Rezoning Plat

766 and 770 Ledford Street

PETITION NO: Z-27
HEARING DATE (PC): 06-06-17
HEARING DATE (BOC): 06-20-17
PRESENT ZONING: GC
PROPOSED ZONING: RM-12
PROPOSED USE: Townhomes
SIZE OF TRACT: 0.5077 acres
DISTRICT: 17
LAND LOT(S): 422
PARCEL(S): 10,18
TAXES: PAID X **DUE** _____
COMMISSION DISTRICT: 3

ZONING COMMENTS:

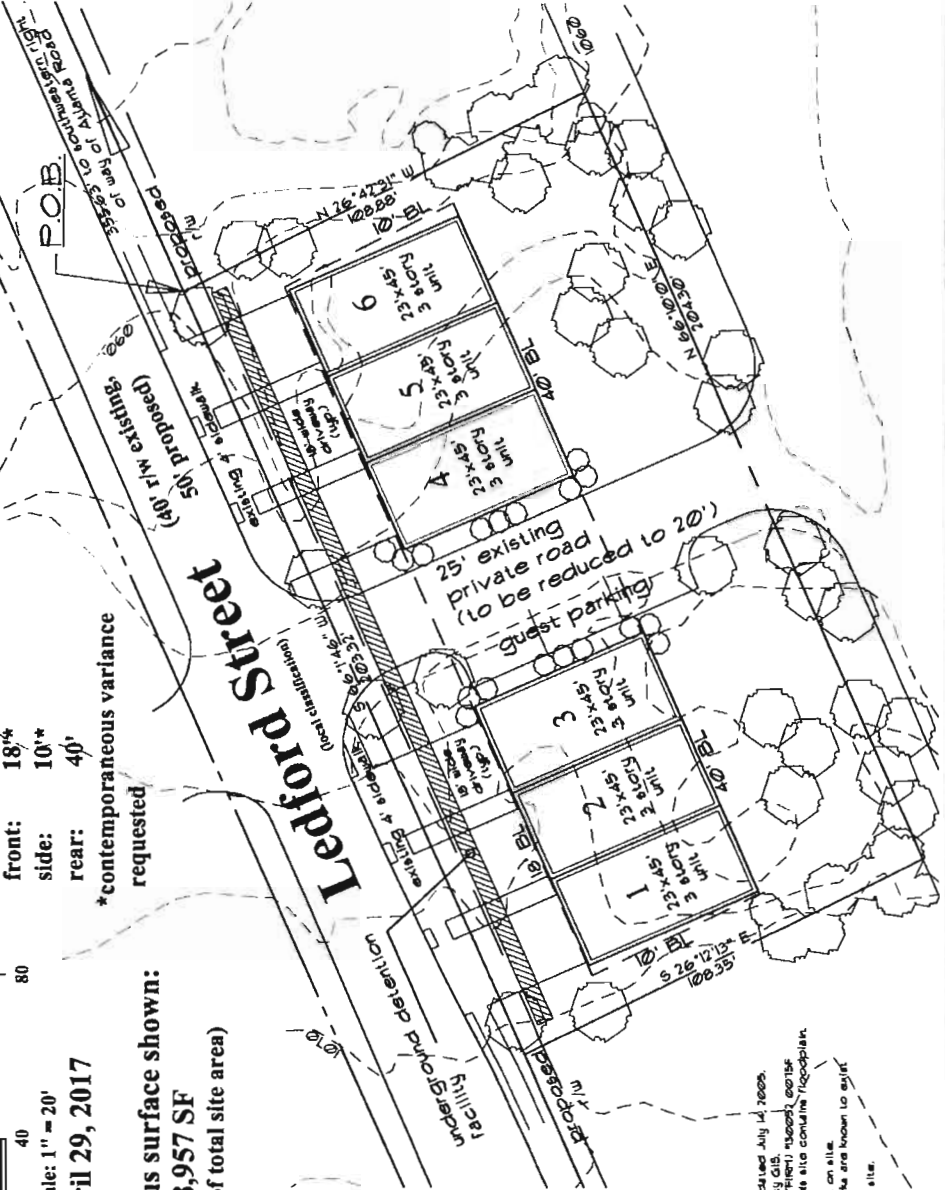
1. Waive the minimum lot size from 80,000 square feet to 22115 square feet;
2. Waive the front setback from 50 feet to 18 feet;
3. Waive the side setbacks from 35 feet to 10 feet.

This project must comply with the Cobb County Tree Ordinance. Full compliance may be difficult to achieve due to the total amount of proposed impervious surface, along with the lack of natural/landscaped areas. Applicant should consider reducing the number and/or size of the proposed units.

1. This site is located to the south of Ledford Street just west of Atlanta Road. The site has been recently cleared and average slopes are less than 5%. The entire site drains to east into and through the adjacent commercial parcel.
2. Stormwater management will likely be provided in an underground system under the driveways along the front of the site.

Ledford Street is classified as a local and according to the available information the existing right-of-way does not meet the minimum requirements for this classification.

Recommend applicant consider entering into a development agreement pursuant to O.C.G.A. 36-71-13 for dedication of the following system improvements to mitigate traffic concerns: a) donation of right-of-way on the south side of Ledford Street, a minimum of 25' from the roadway centerline.

Recommend curb, gutter, and sidewalk along the Ledford Street frontage.
